To: Charles Perkins-Witherington, Director of Planning and Community Development
From: Sam Hubbard, Development Planner
Date: 1/10/2018
Re: PC #17-012: St. James Parish

Re: **St. James Parish – Plan Commission Conditions of Approval**
Demolition of Existing School Building and Addition / Renovation at Existing Church
831 North Arlington Heights Road

PLAN COMMISSION PC #17-012
St. James Parish Subdivision
820 N. Arlington Heights Road
PUD, SU Amnd, Pre/Final Plat of Subdivision, Parking Variation
Round 4

**SIGNAL EXHIBIT
(OPTION 1)**

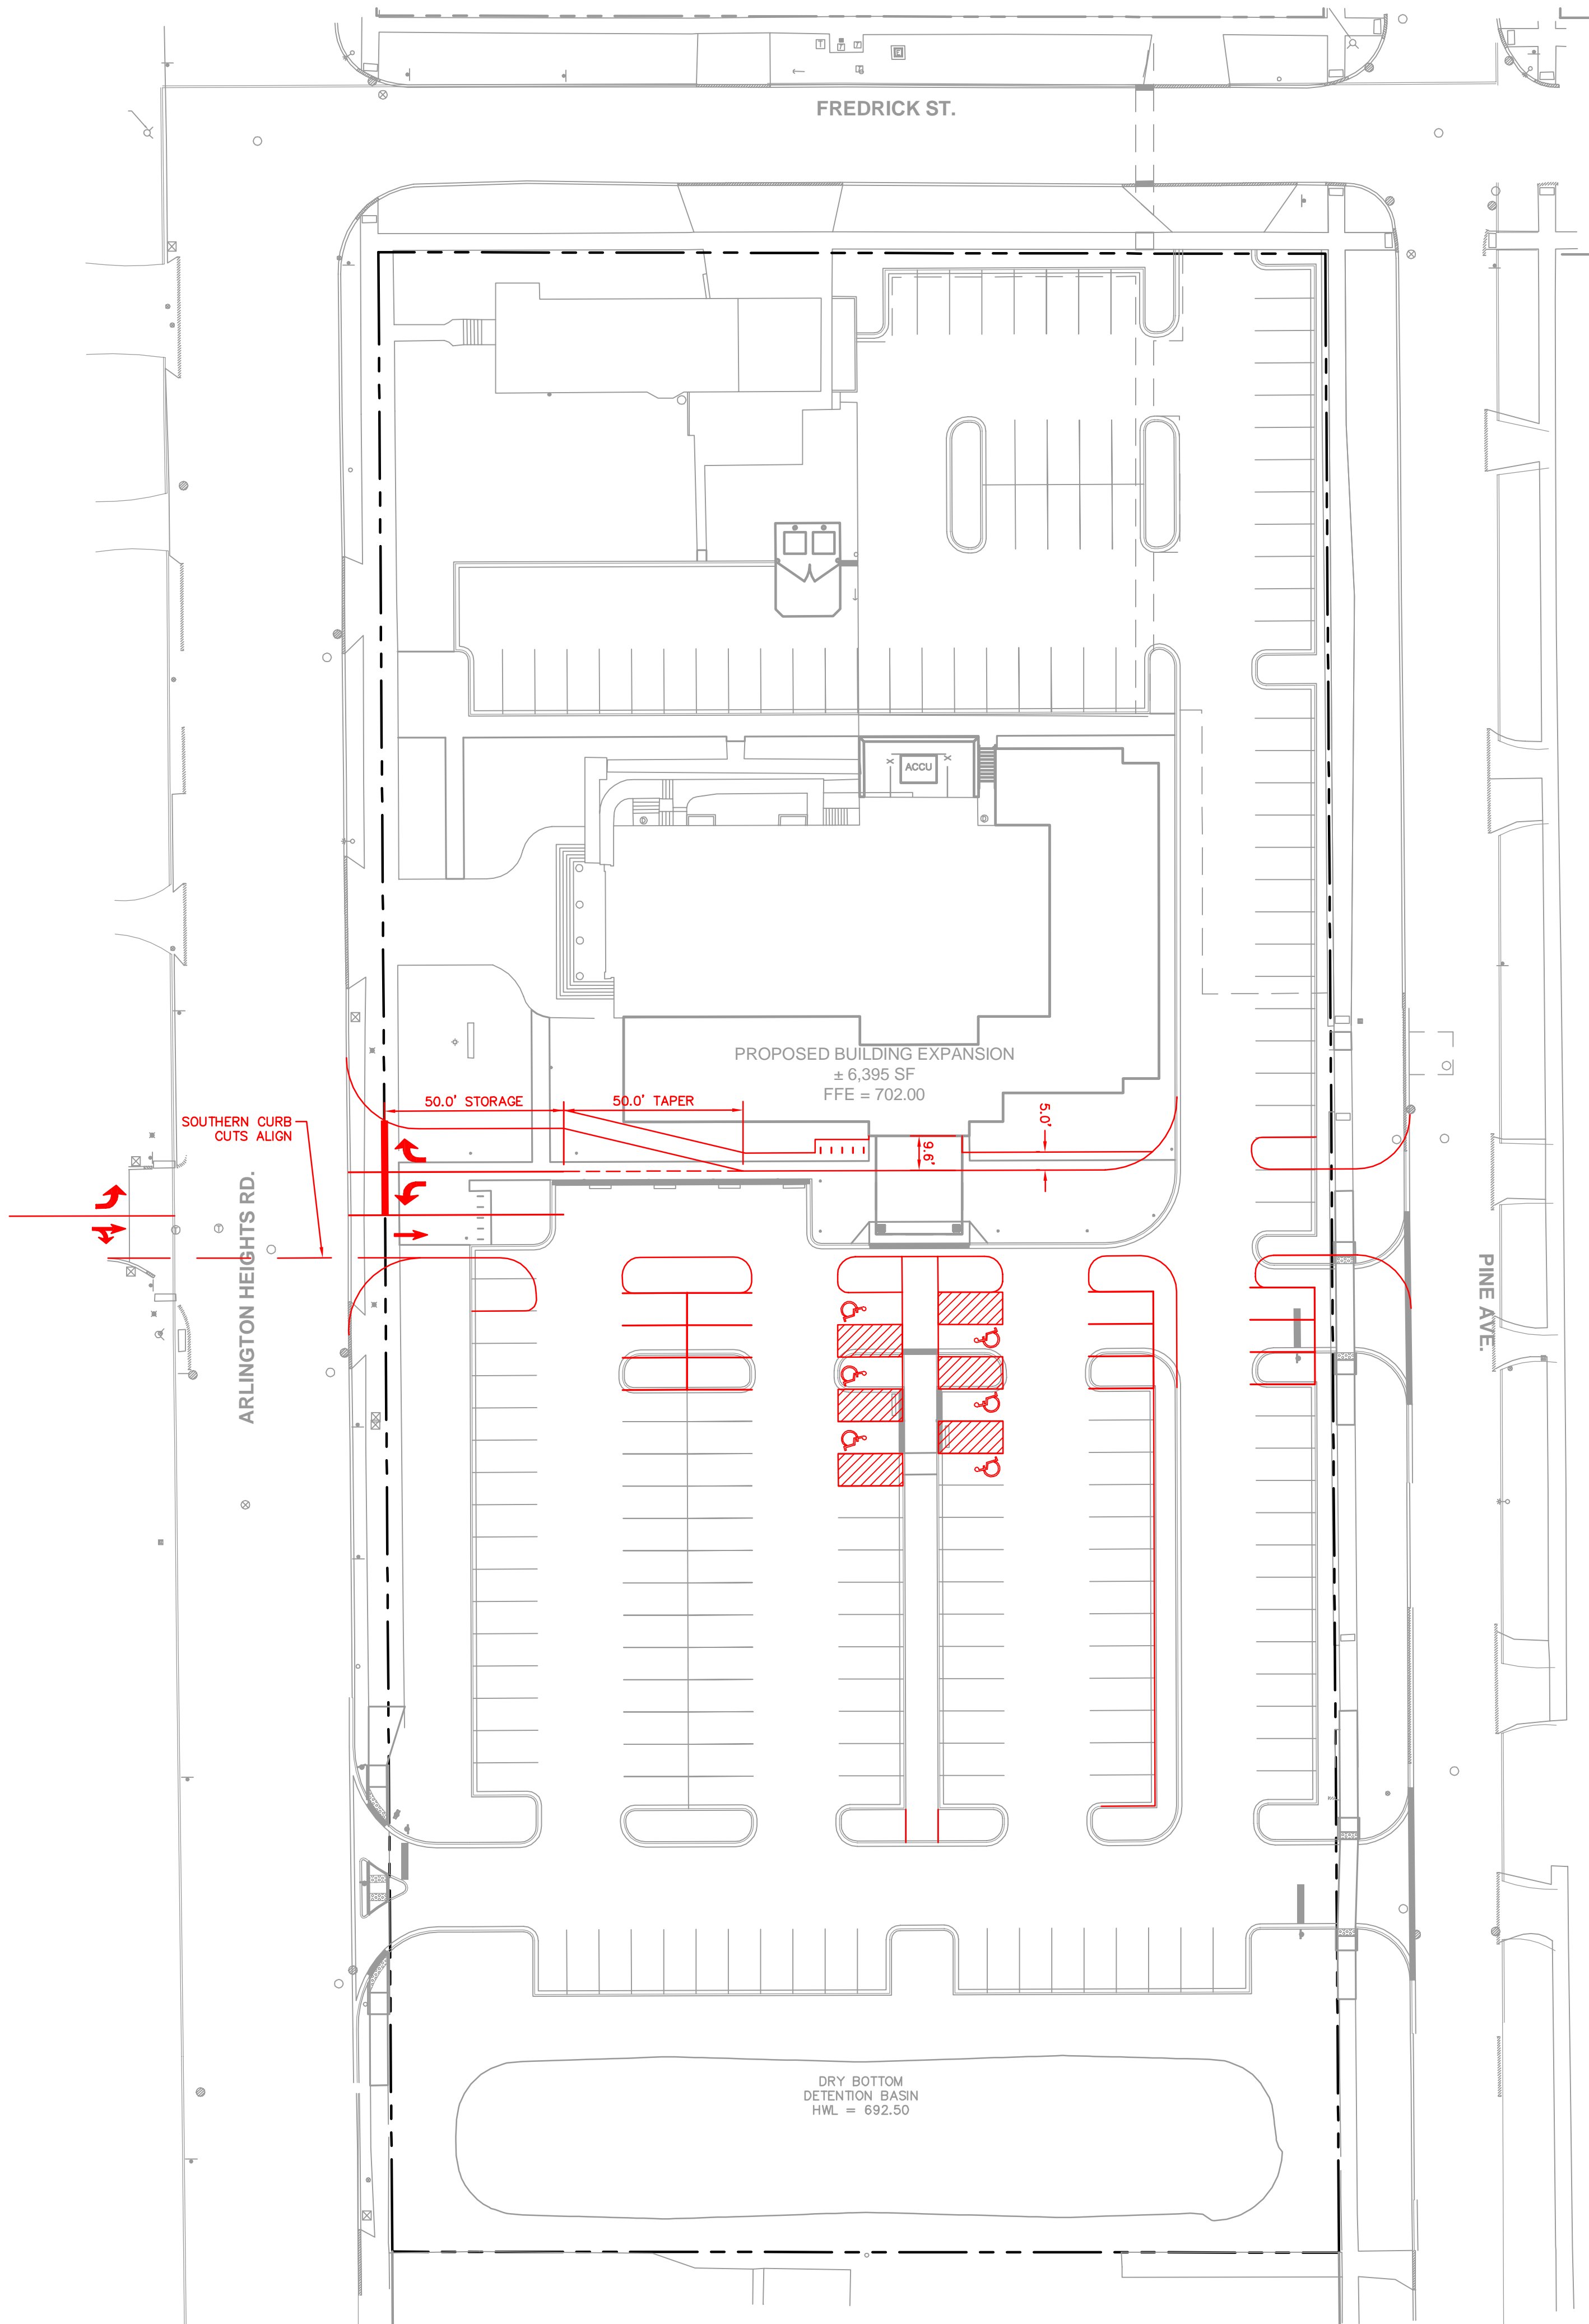
- DISADVANTAGES
1. THE PARISH WOULD INCUR SIGNIFICANT COSTS TO IMPROVE / UPGRADE THE EXISTING TRAFFIC SIGNAL.
 2. THE NORTHERN EDGE OF THE MAIN DRIVE AISLE IS VERY CLOSE TO THE NEW ADDITION, ESPECIALLY ADJACENT TO THE NEW MAIN ENTRY; SAFETY CONCERN.
 3. THERE WOULD BE NO EXTERIOR GATHERING SPACE AFTER MASS; NO LEGITIMATE OVERHANG FOR PARISHIONERS.
 4. ALL OF THE HANDICAPPED PARKING SPACES WOULD BE SOUTH OF THE NORTH DRIVE.
 5. THIS ARRANGEMENT COULD BECOME A 'CUT-THRU' FROM ARLINGTON HEIGHTS ROAD TO THE NEIGHBORHOOD, OR VICE VERSA.
 6. WITH MORE VEHICLES BEING BROUGHT TO THE NORTH (ADJACENT TO ADDITION), PARISHIONERS WOULD HAVE TO CROSS A BUSIER DRIVEWAY TO GET TO BUILDING; SAFETY CONCERN.

SIGNAL EXHIBIT (OPTION 2)

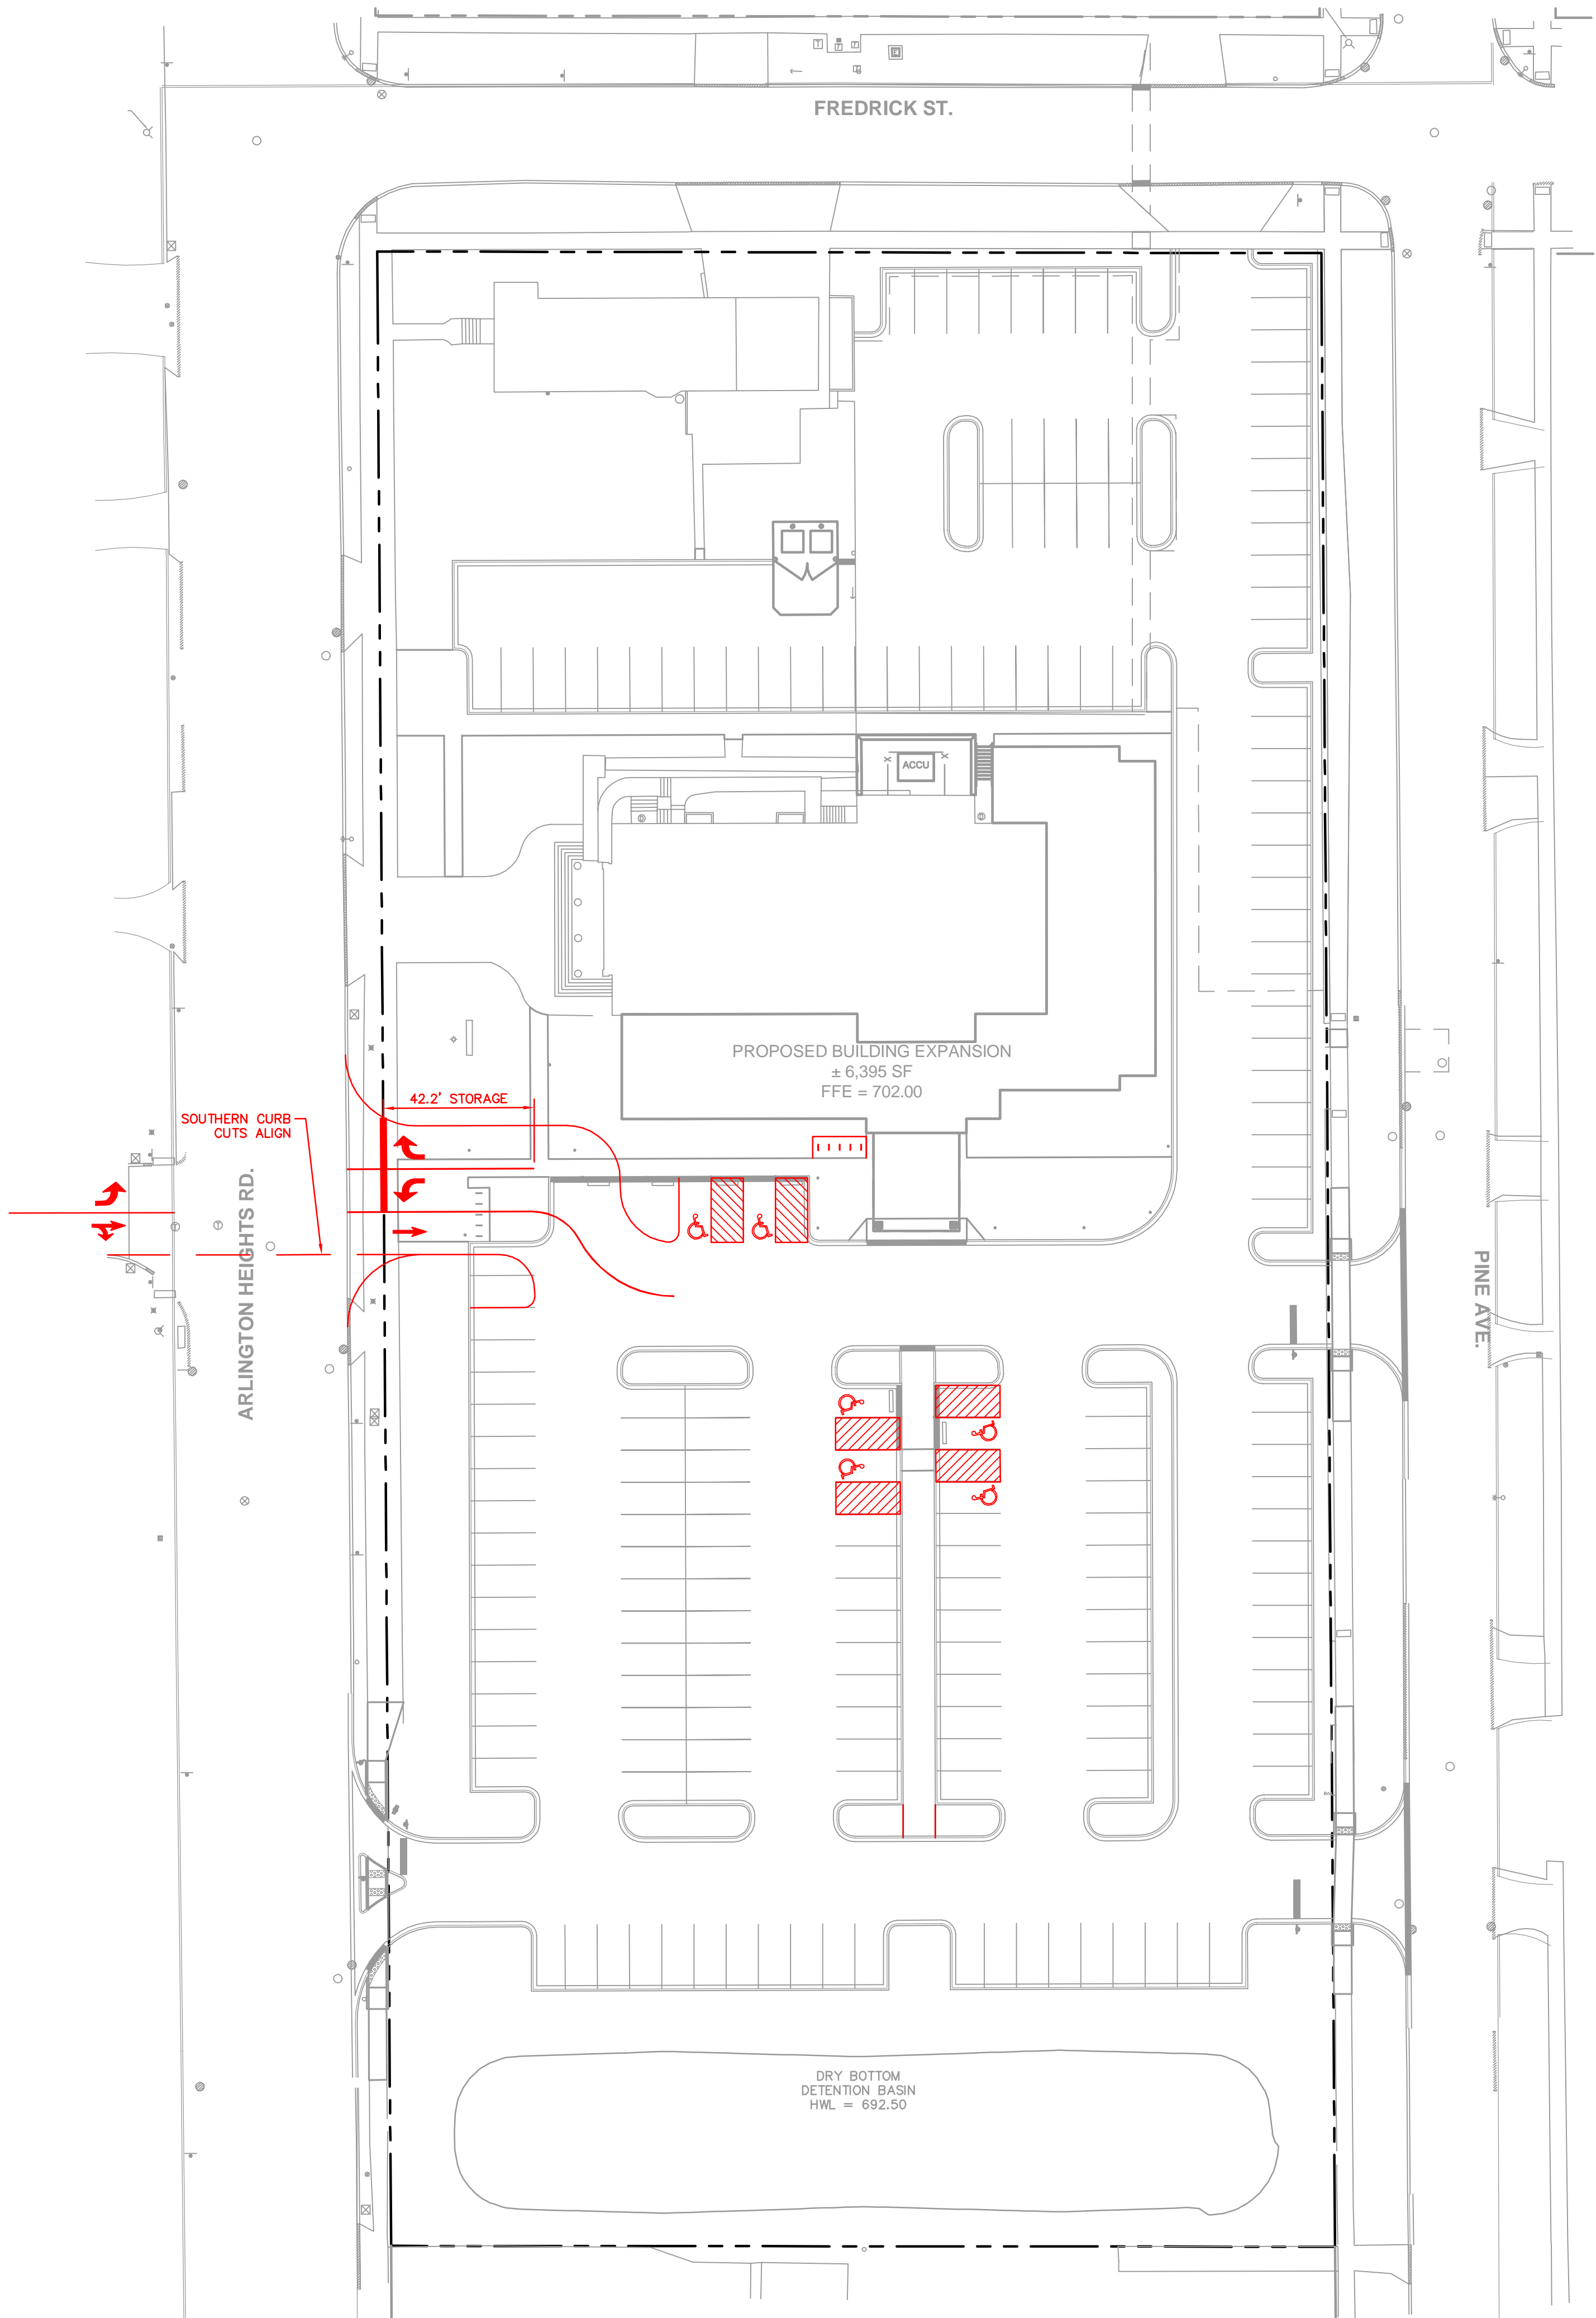
1. THE PARISH WOULD INCUR SIGNIFICANT COSTS TO IMPROVE / UPGRADE THE EXISTING TRAFFIC SIGNAL.
2. THE NORTHERN EDGE OF THE MAIN DRIVE / AISLE IS VERY CLOSE TO THE NEW ADDITION, ESPECIALLY ADJACENT TO THE NEW MAIN ENTRY; SAFETY CONCERN.
3. THERE WOULD BE NO EXTERIOR GATHERING SPACE AFTER MASS; NO LEGITIMATE OVERHANG FOR PARISHIONERS.
4. MAJORITY OF THE HANDICAPPED PARKING SPACES WOULD BE SOUTH OF THE NORTH DRIVE.
5. THIS ARRANGEMENT COULD BECOME A 'CUT-THRU' FROM ARLINGTON HEIGHTS ROAD TO THE NEIGHBORHOOD, OR VICE VERSA.
6. WITH MORE VEHICLES BEING BROUGHT TO THE NORTH (ADJACENT TO ADDITION), PARISHIONERS WOULD HAVE TO CROSS A BUSIER DRIVEWAY TO GET TO BUILDING; SAFETY CONCERN.
7. GEOMETRY OF THIS CONCEPT IS NOT PRACTICAL.
